Subject: **Docket Nos. 50-361 and 50-362**
Revision to Third Ten-Year Inservice Inspection (ISI)
Interval Requests ISI-3-27 and ISI-3-28
Use of Structural Weld Overlay and Associated Alternative
Repair Techniques
San Onofre Nuclear Generating Station, Units 2 and 3

Revision 1 to Relief Request ISI-3-27

Use of Structural Weld Overlay and Associated Alternative Repair Techniques

Drawings

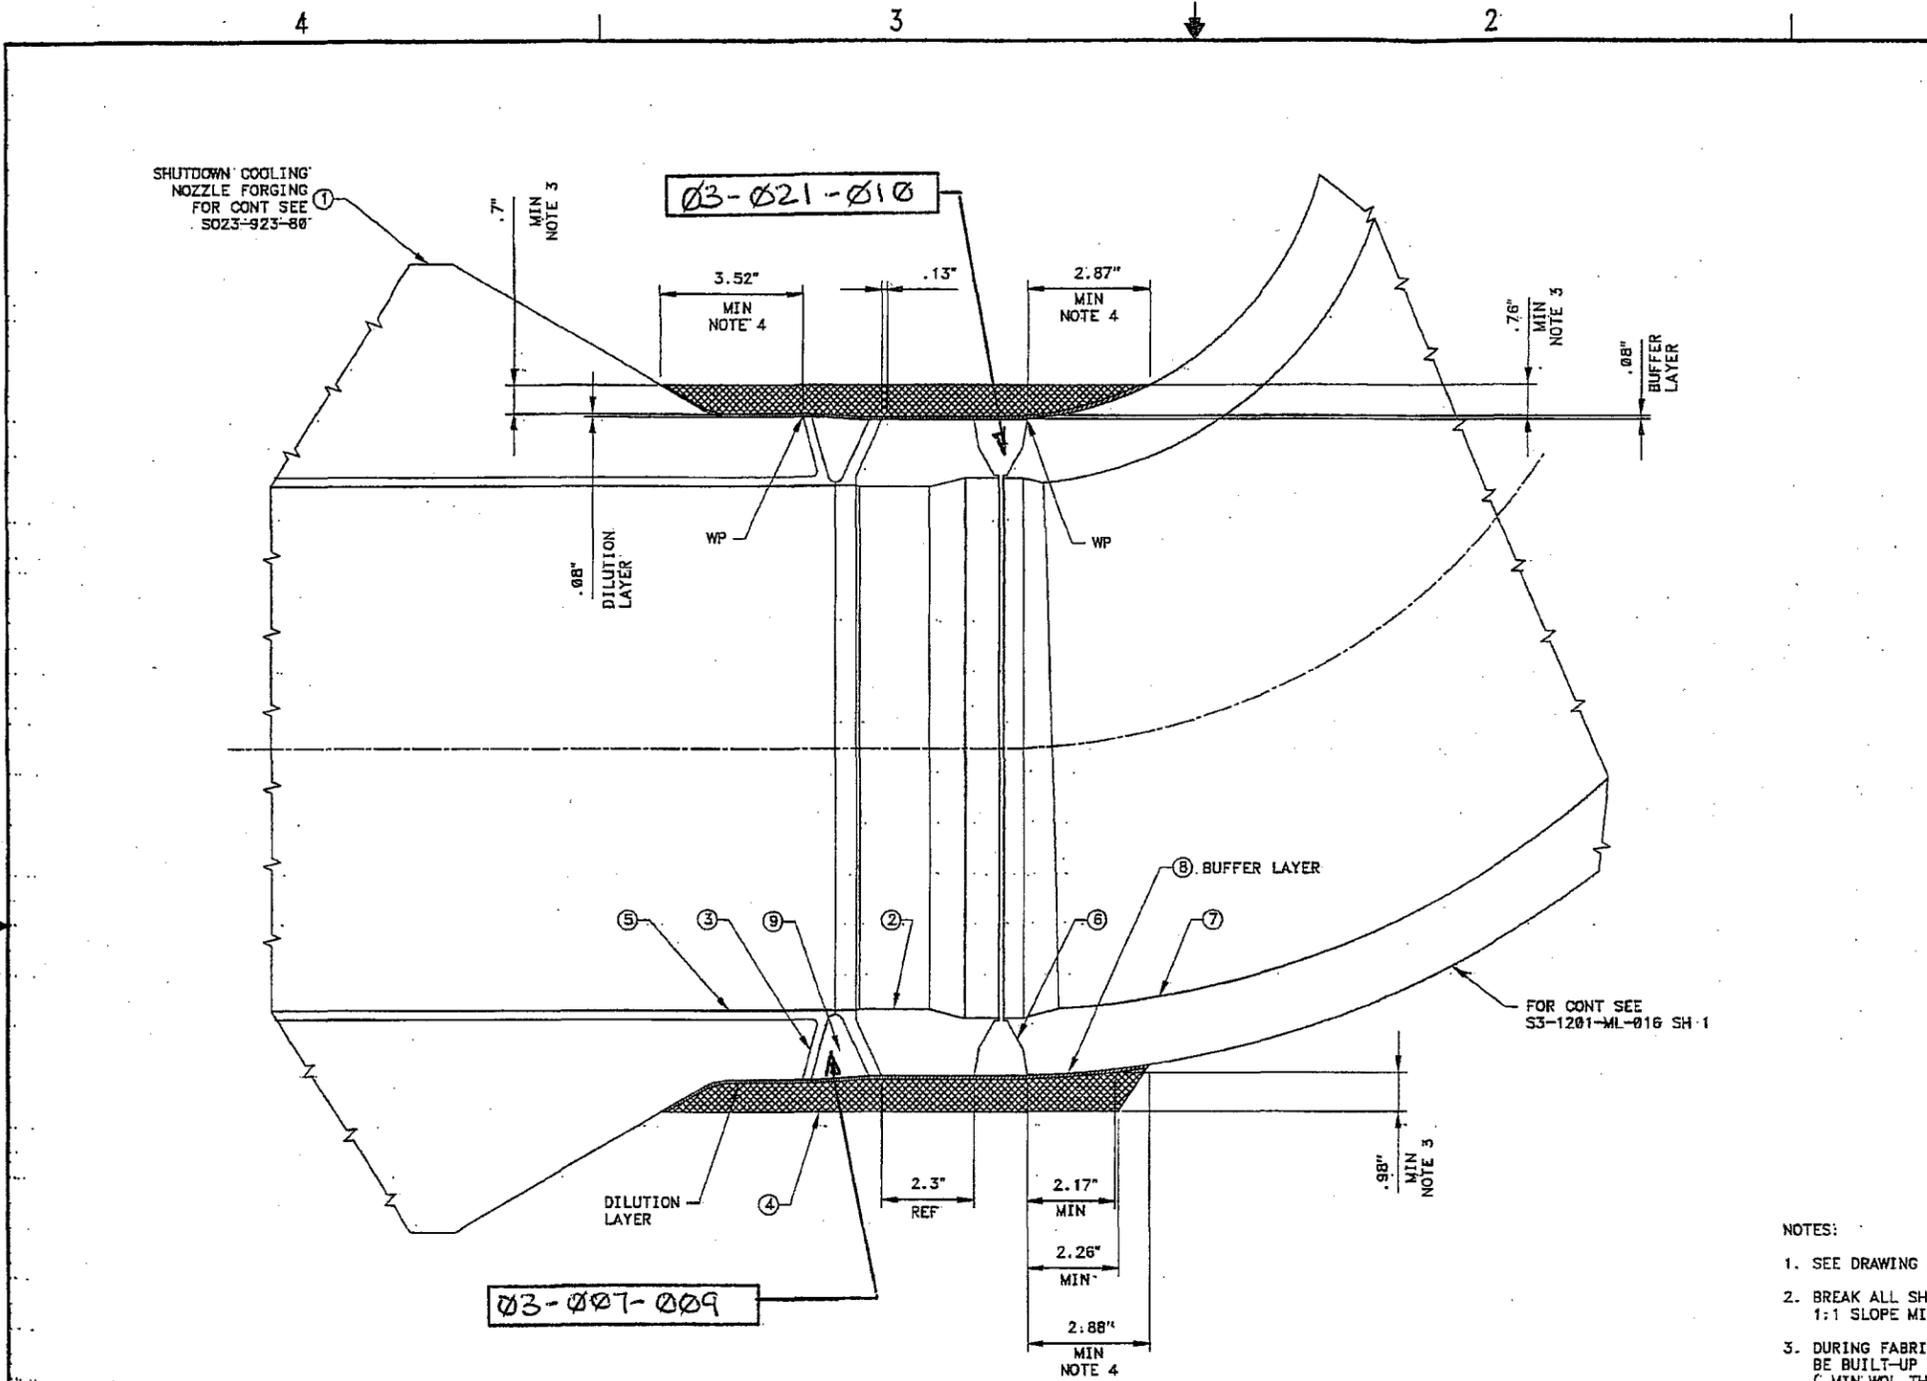
The weld overlays for the Unit 3 RCS Hot Leg nozzles must be implemented during the current Unit 3 Cycle 15 Refueling Outage. During implementation of these weld overlays, SCE has discovered that the physical configuration of the Unit 3 RCS Hot Leg Surge Line includes additional Code-allowed weld build-up that is not specifically detailed on the engineering drawings. The weld overlay was designed to cover the RCS Hot Leg Surge nozzle to safe end dissimilar metal weld and the adjacent stainless steel weld joining the safe end to the pipe. The pipe adjacent to the stainless steel weld, however, was found to be slightly shorter than was shown on the engineering drawings and it contains bands of weld material build-up on either end of the pipe. With this configuration, the weld overlay as originally designed would have ended on top of a weld build-up rendering the buildup, as well as the adjacent pipe to elbow weld impossible to inspect via Ultrasonic Testing (UT). To resolve this issue, the design of the weld overlay has been modified to increase the length of the overlay and fully cover the pipe weld material build-up to elbow weld as well as the pipe to elbow weld and provide an overlay that is UT inspectable. The purpose of Revision 1 to ISI-3-27 and Revision 1 to ISI-3-28 is to include this additional pipe-to-elbow weld in the scope of the Relief Requests.

The weld overlays for the Unit 3 RCS Hot Leg nozzles must be implemented during the current Unit 3 Cycle 15 Refueling Outage. During implementation of these weld overlays, SCE has discovered that the physical configuration of the Unit 3 RCS Hot Leg Surge Line includes additional Code-allowed weld build-up that is not specifically detailed on the engineering drawings. The weld overlay was designed to cover the RCS Hot Leg Surge nozzle to safe end dissimilar metal weld and the adjacent stainless steel weld joining the safe end to the pipe. The pipe adjacent to the stainless steel weld, however, was found to be slightly shorter than was shown on the engineering drawings and it contains bands of weld material build-up on either end of the pipe. With this configuration, the weld overlay as originally designed would have ended on top of a weld build-up rendering the buildup, as well as the adjacent pipe to elbow weld impossible to inspect via Ultrasonic Testing (UT). To resolve this issue, the design of the weld overlay is being modified to increase the length of the overlay and fully cover the pipe weld material build-up to elbow weld as well as the pipe to elbow weld and provide an overlay that is UT inspectable.

- NOTES:
- SEE DRAWING S023-923-1-001 FOR BILL OF MATERIALS.
 - BREAK ALL SHARP EDGES. BLEND OVERLAY INTO THE NOZZLE. 1:1 SLOPE MINIMUM.
 - DURING FABRICATION WELD OVERLAY SHALL NOT BE BUILT-UP MORE THAN 1/4" BEYOND MINIMUM THICKNESS (MIN WOL THICKNESS + .08" DILUTION/BUFFER) WITHOUT PRIOR ENGINEERING APPROVAL.
 - THE SPECIFIED WELD OVERLAY SHOULD NOT EXCEED THE MINIMUM LENGTH BY MORE THAN 1/2" ON EITHER END WITHOUT PRIOR ENGINEERING APPROVAL.
